## CITY OF ALBUQUERQUE

RE: Alameda Luxury Apartments 8400 Alameda Blvd NE Conceptual Grading and Drainage Plan Engineer's Stamp Date: 07/26/19

**Hydrology File: C20D057**

# SCOTT M McGEE PE, LLC CIVIL ENGINEER

#### STREET CAPACITY

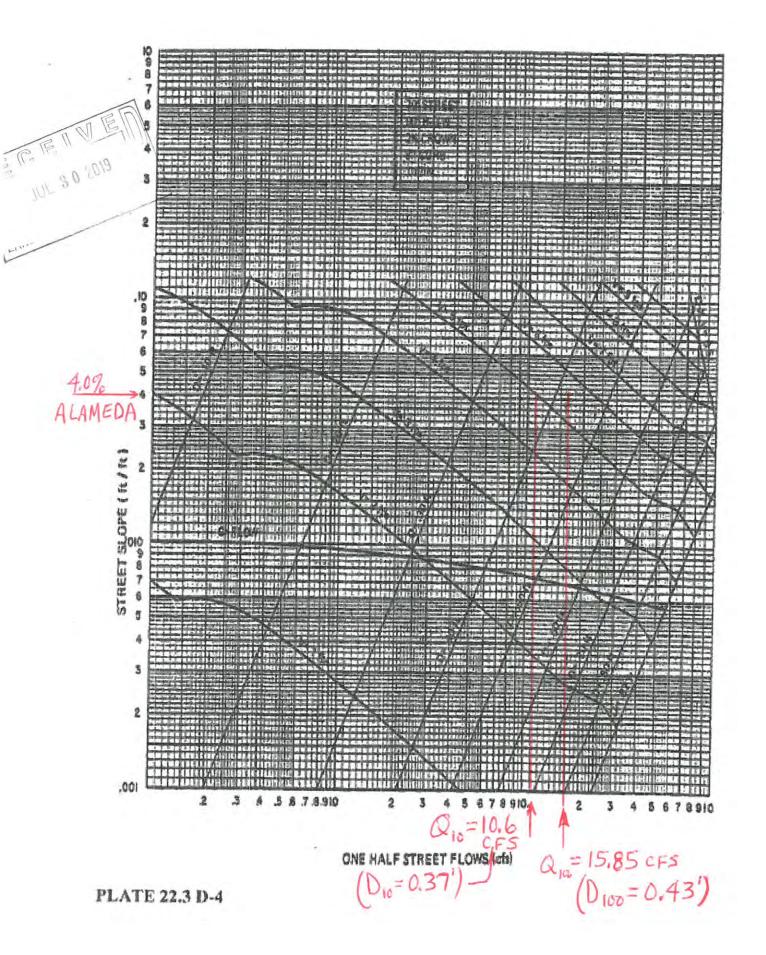
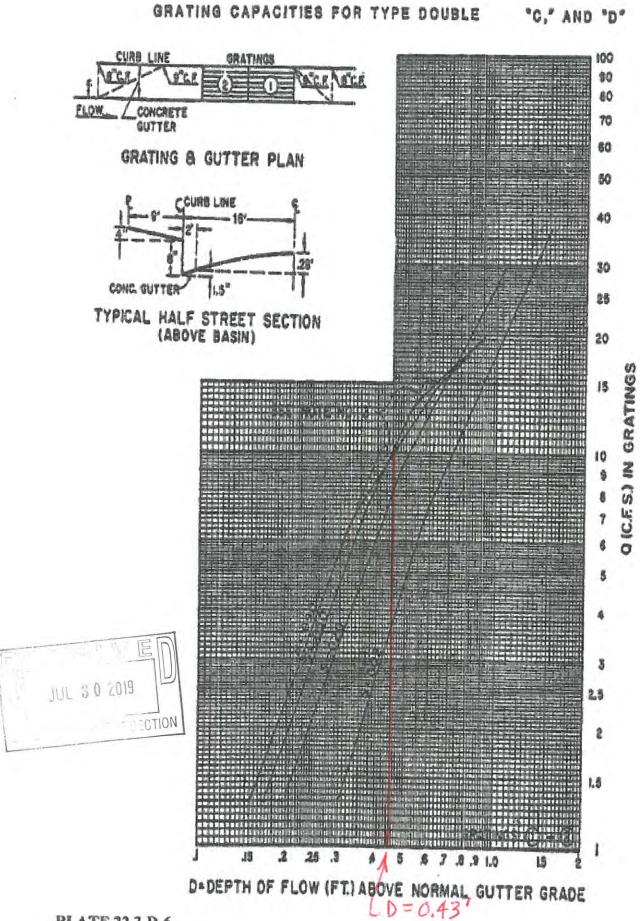
- 4. A section of the pond (along Barstow), has been added to the plan.
- 5. A street capacity nomograph (Plate 22.3 D-4), is attached showing 10-yr and 100-yr (10.6 and 15.8 CFS) flows. The 100-yr flow is based on 1385' of Alameda with ½ R/W width of 62' (1.98 acre) using 47% 'C' and 53% 'D' land types for a unit discharge of 4.28 CFS. The Discharge from Hope Plaza was based on 3.08 acres at the allowable discharge of 2.38 CFS/AC Total Q= 8.5 + 7.3= 15.8 CFS.
